PCS Conduits – Change in Proprietary Material Mixture

Product Change Notification

PCN_292_18.05.30_002_PCS, PCSL

Product Specification Change

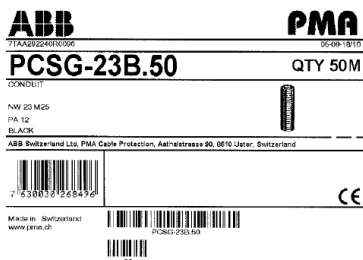
In order to clarify the distinction between the OLD and NEW material, we are implementing the following identification methods that will be in effect until October 2019:

This material complies with EN45545-2 HL2 and will not be certified to NFPA130

See PCN: **PCN_292_18.05.30_002_PCS_PCSL**
